Addendum No. 2
August 24, 2022

Project: **St. Mary Catholic School Addition & Remodel**
812 N. State Avenue
Dell Rapids, South Dakota 57022
Architecture Incorporated Project #2788

Scope of this Addendum:

PHASING PLAN

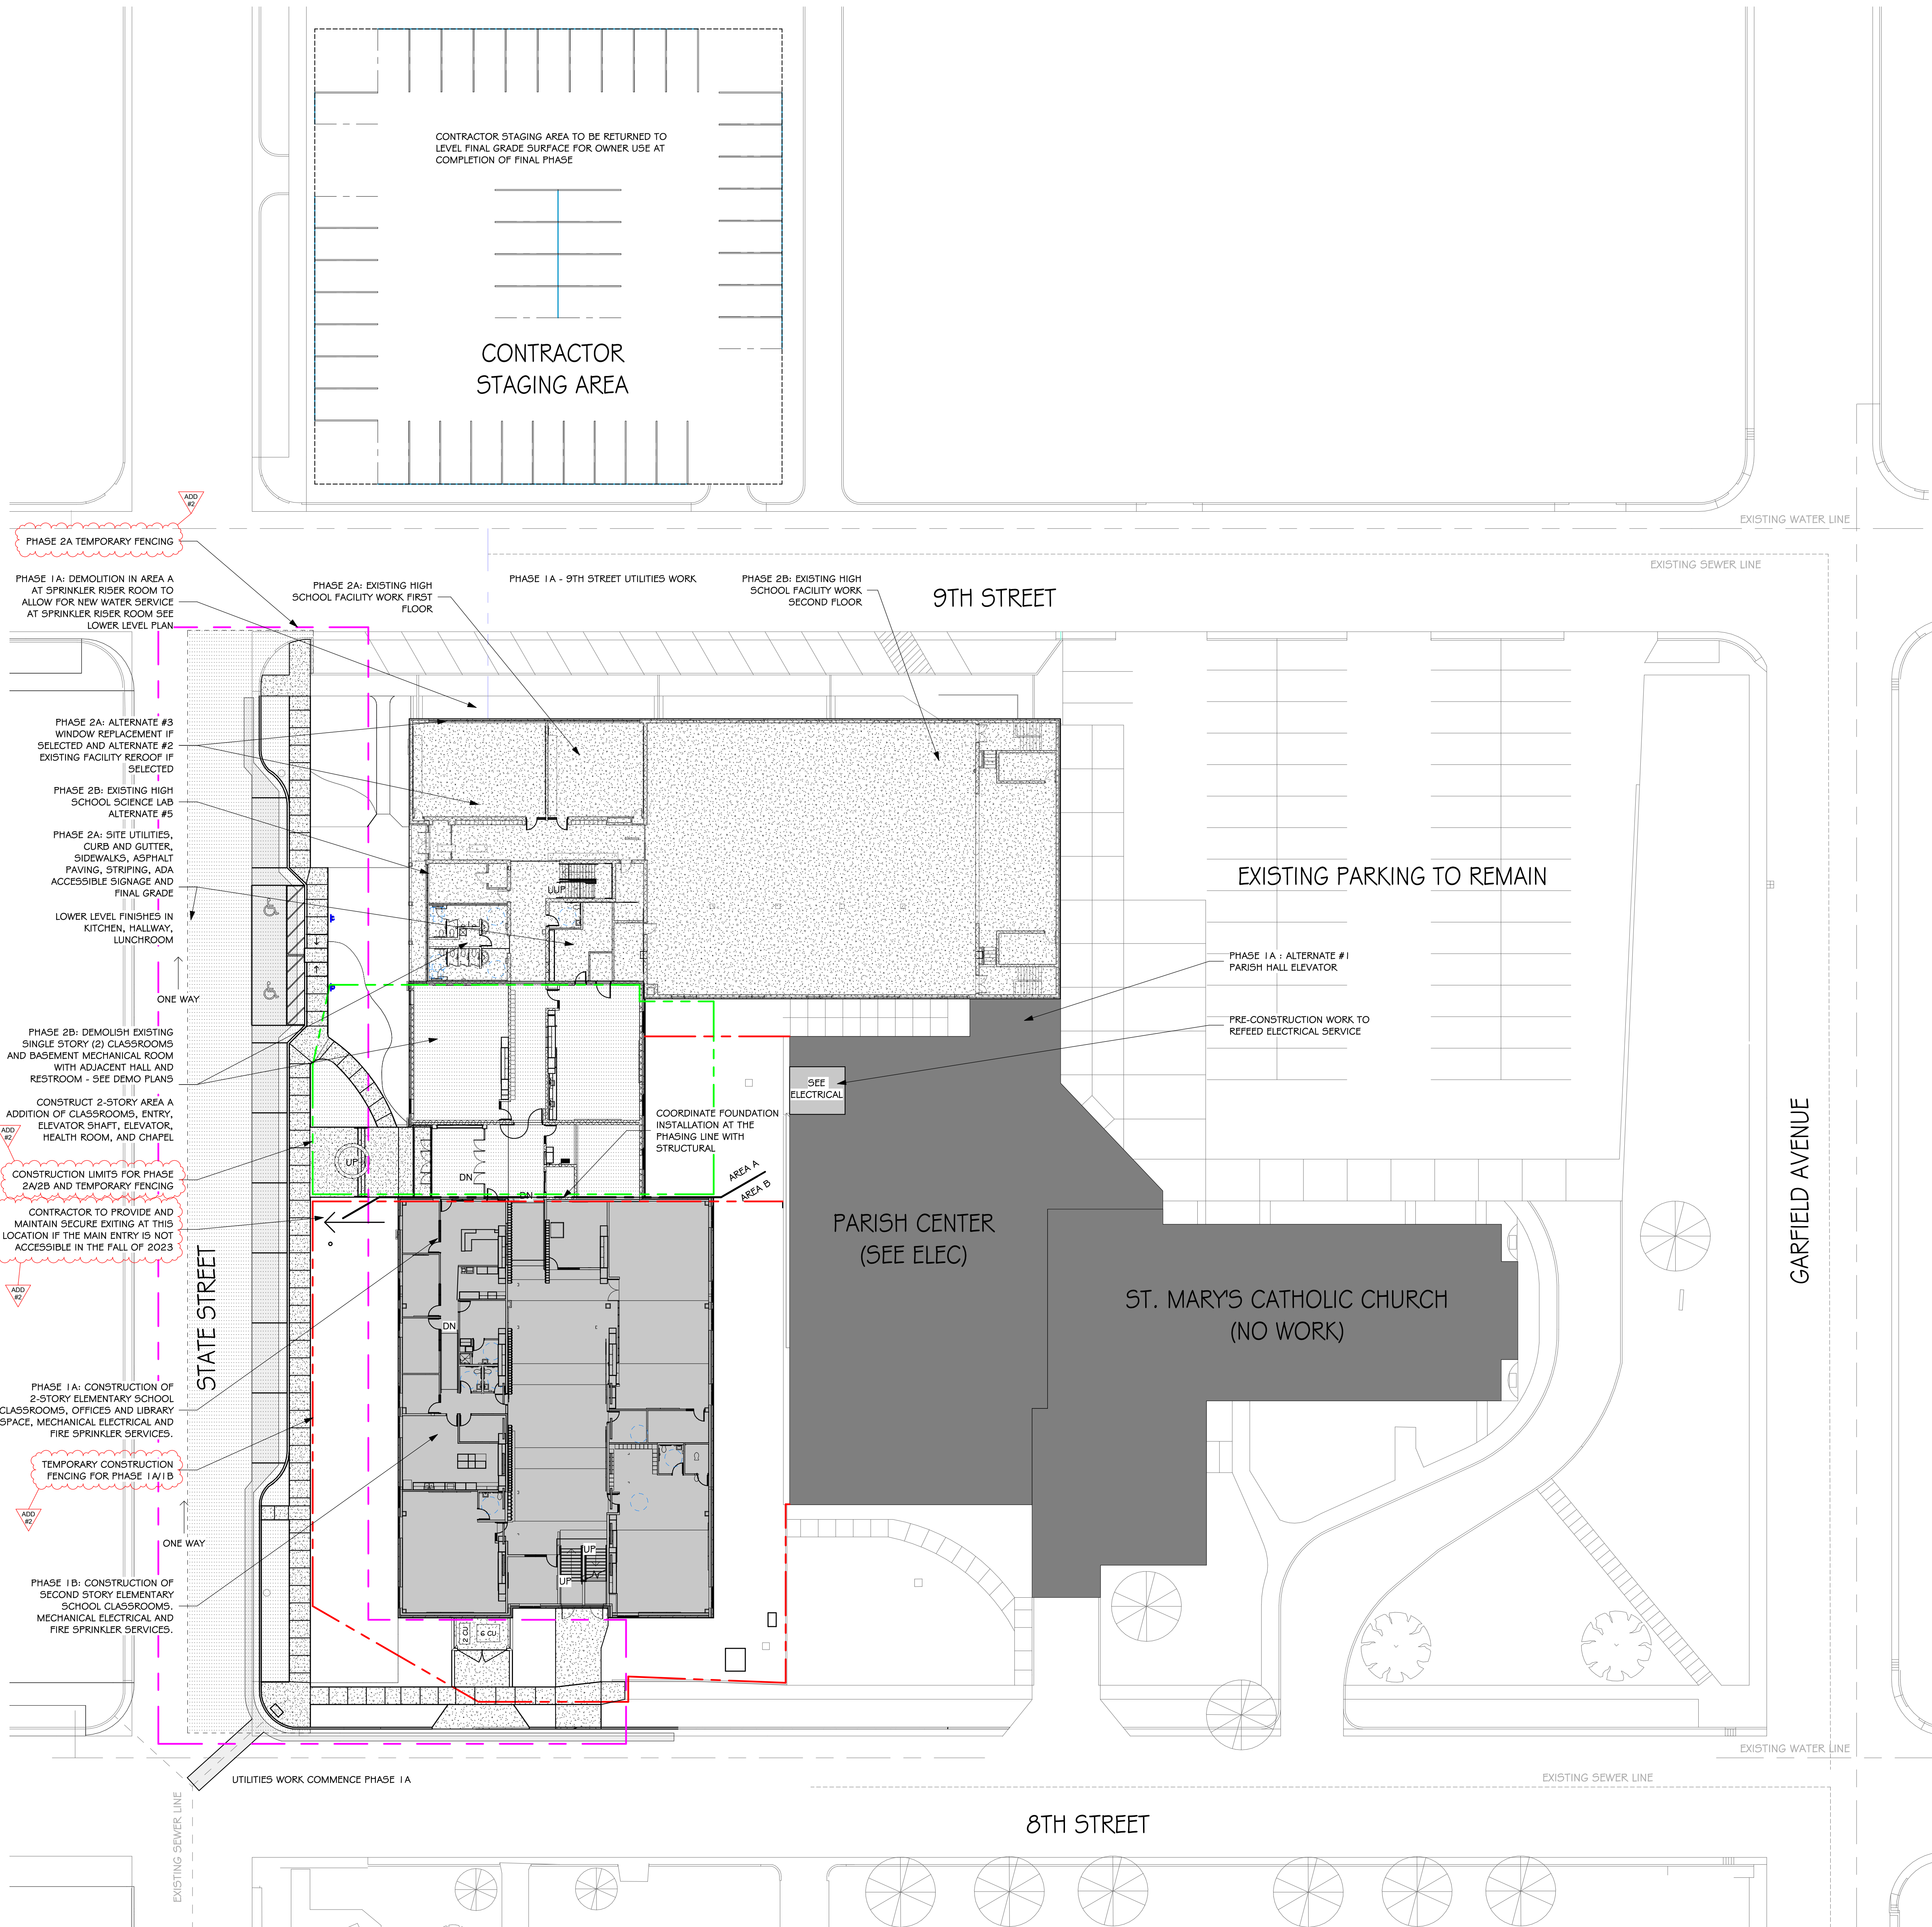
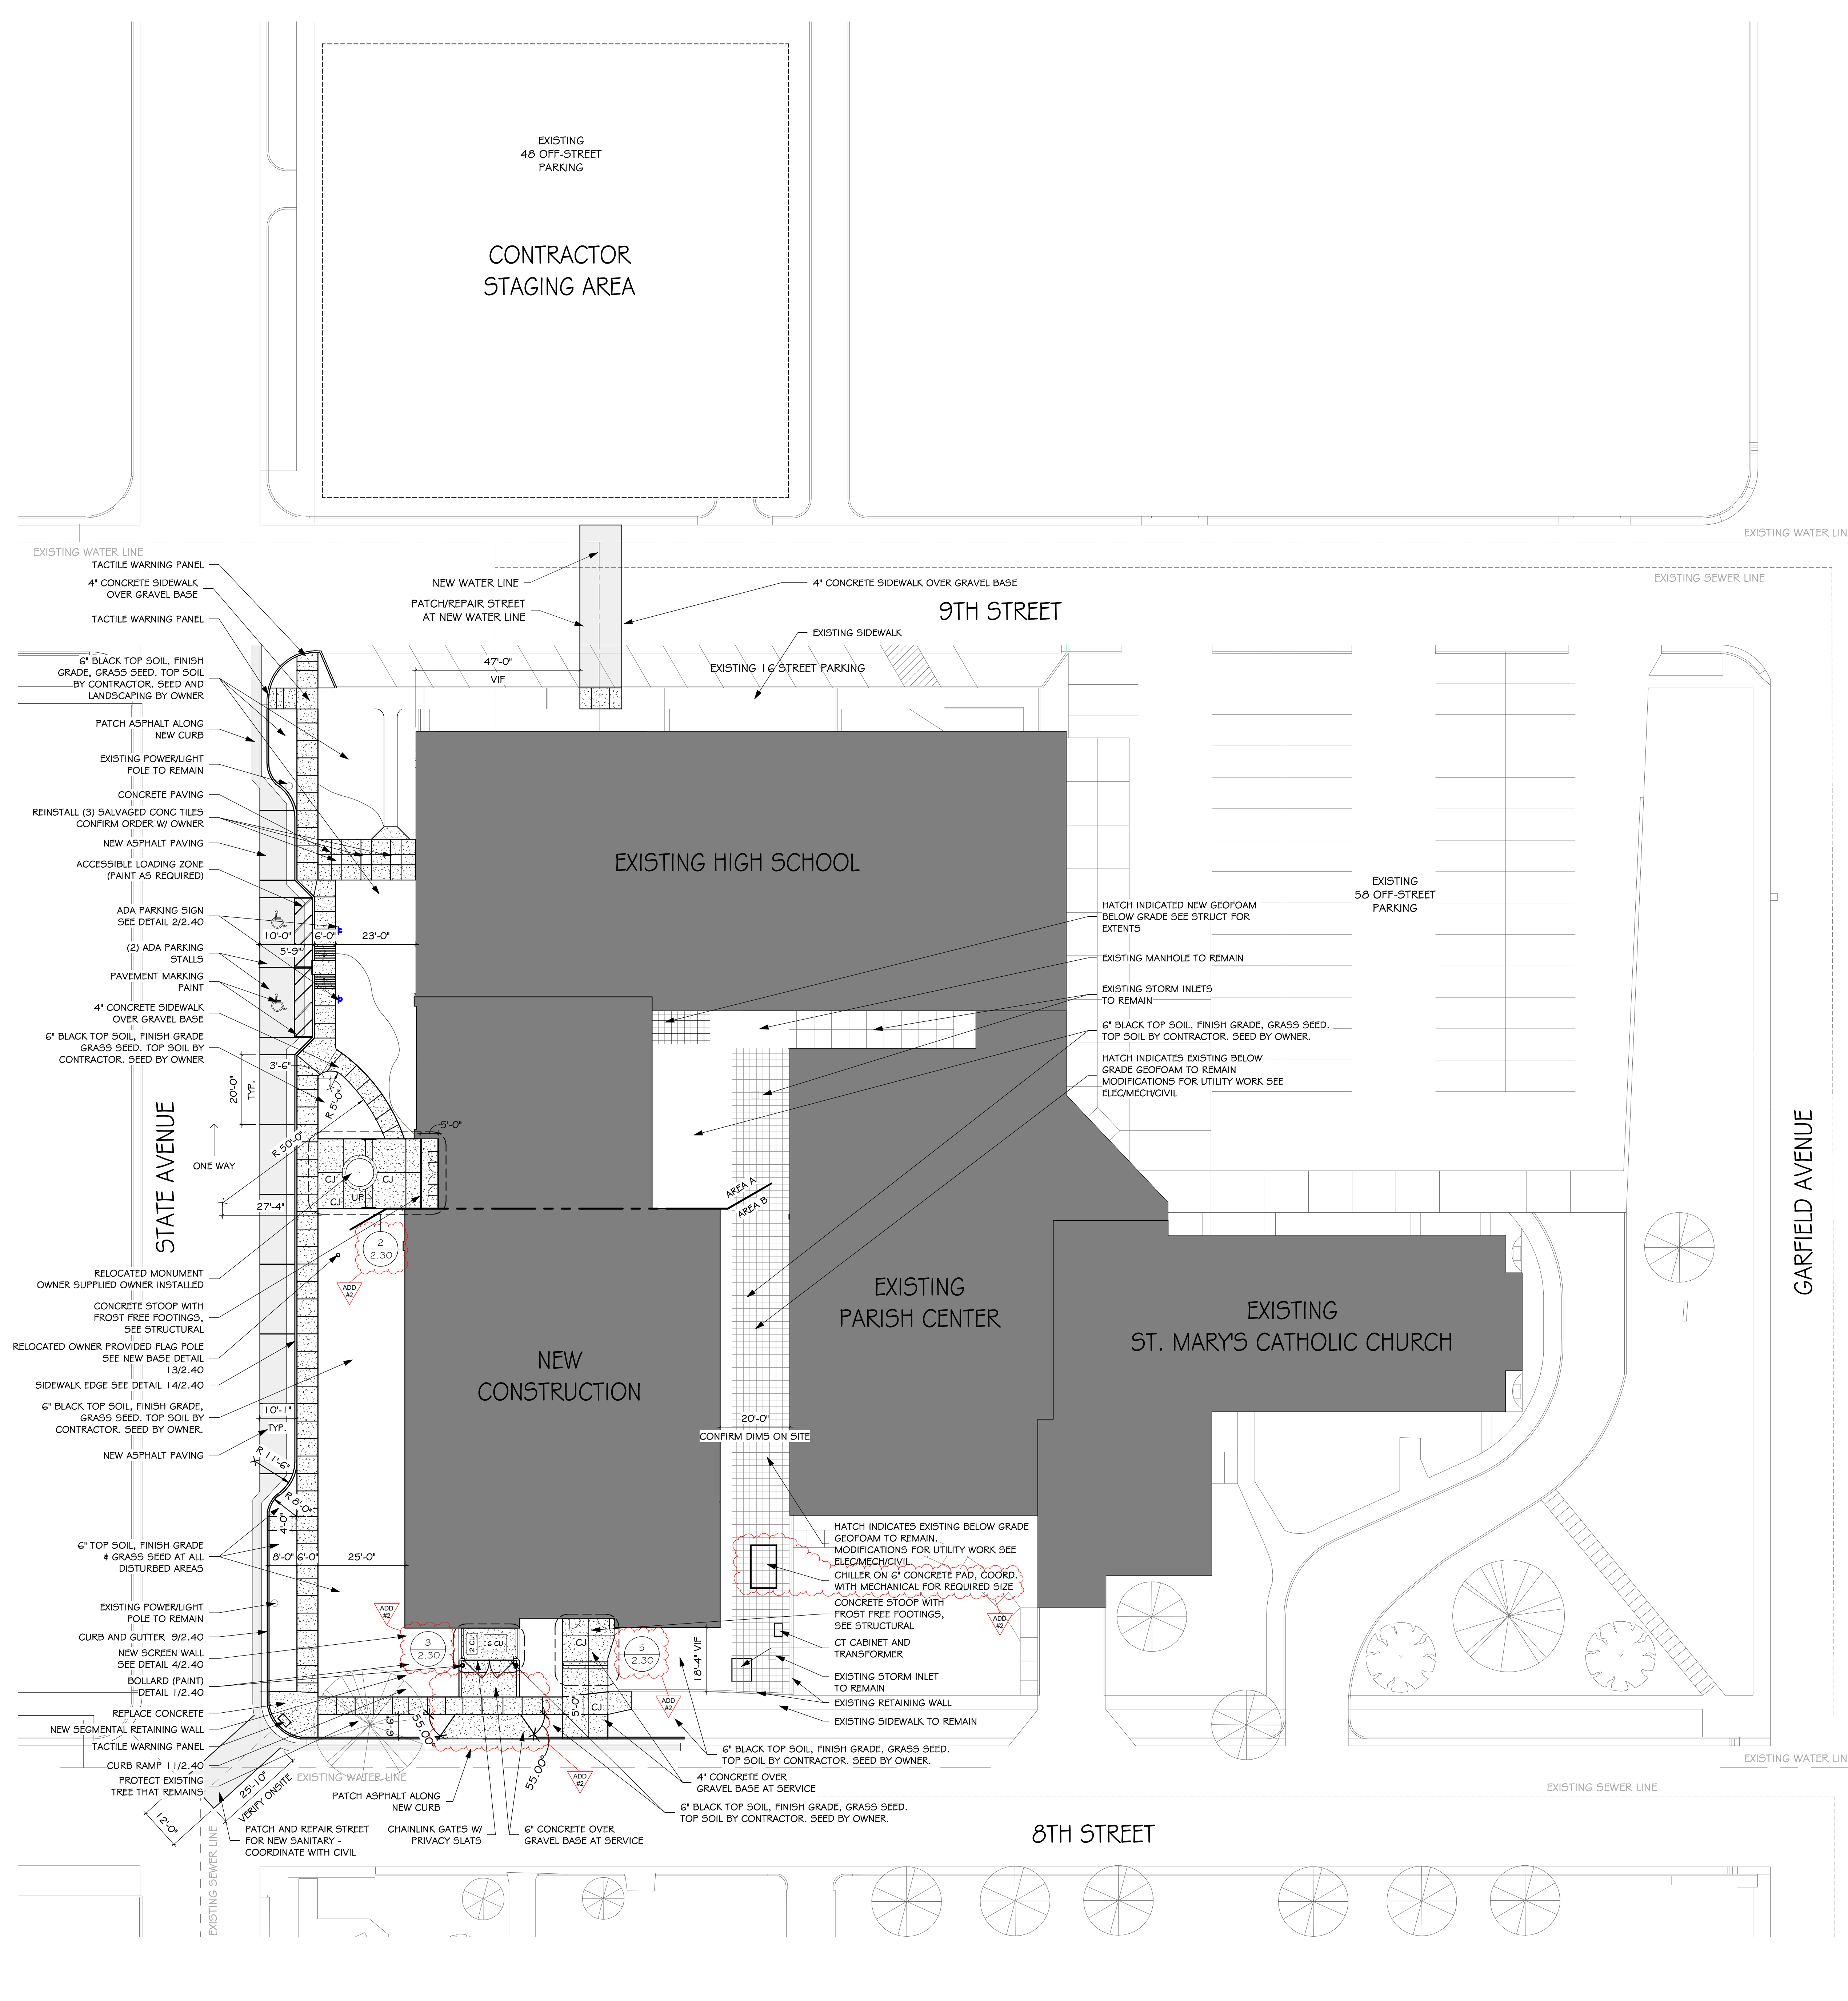
iii. Reference the Phasing Plan for temporary fencing locations; see revised sheet 1.21 (attached 8/23/2022).

- a. Incorporate Revised Sheet 1.21 – PHASING PLAN (DATED 8/23/22)
